Geotechnical Addendum

Group Delta Project No. LA1579A

Subject: Geotechnical Addendum – Response to Comments from City of Walnut
Proposed Residential Development
Tentative Tract No. 72798
Assessor's Parcel Numbers: 8709-093-001, 002, & 003
Northeast corner of North Lemon Avenue & La Puente Road
City of Walnut, California

PROJECT NUMBER:	LA1579A
SCALE:	AS SHOWN
FIGURE NUMBER:	1

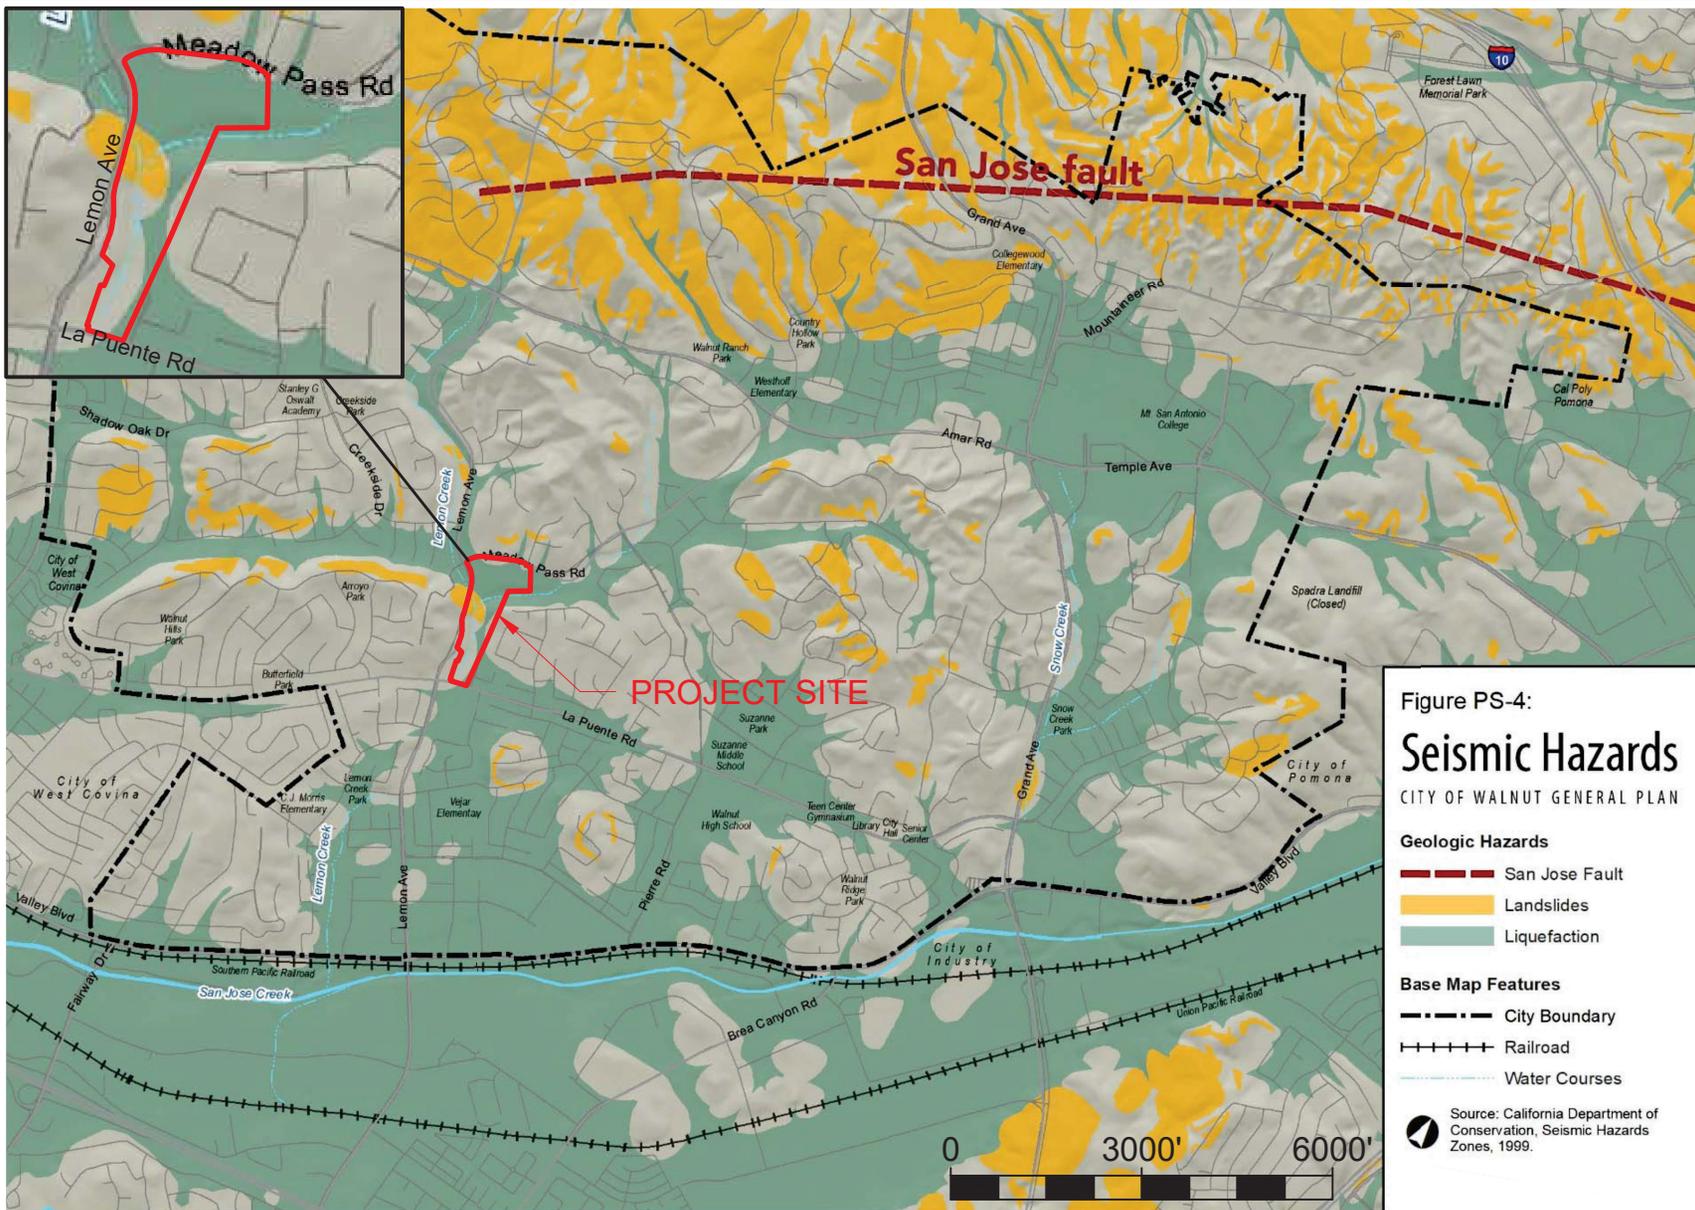
The City's General Plan Figure PS-4 Seismic Hazards identifies a potential landslide area on the project site. The project geotechnical references that the site does not include slopes recognized for the potential of seismically induced landslide hazards as shown in Figure 7. The geotechnical report Figure 7 is not consistent with General Plan Figure PS-4. In the Draft EIR we will be addressing Seismic Hazards identified in the General Plan. For consistency, we would like to see the project geotechnical report address the landslide hazard identified in the General Plan and incorporate it into the geotechnical report analysis.

The City of Walnut General Plan Figure PS-4 is shown in Figure 1. The General Plan figure is a regional map identifying areas requiring investigation for seismically induced geologic hazards, including Fault Rupture, Landslide, and Liquefaction. The Figure PS-4 is cited as sourced from the California Department of Conservation, Seismic Hazards Zones, 1999. The state Seismic Hazard Zone map was presented in Figure 7 of the Group Delta report. These references should reflect consistent hazard zones.

The regional scale of these maps can be misleading to the actual seismic hazard zone for landslides in relation to the project site. The zone mapped in PS-4 appears to extend from the west facing slope, cross Lemon Creek Road, then cross Lemon Creek, and terminate irregularly within the lower portions of the existing eastern slope. While the state Seismic Hazard Zone map illustrates the same zone, just west of the site, within the hills extending up from Lemon Creek Road. In addition, the identified liquefaction hazard zone on Figure PS-4 is mapped outside of the creek area and within bedrock slope areas. These factors indicate that the location of the hazard areas in relation to the site, needs to be further evaluated at a site-specific scale with site geologic context.
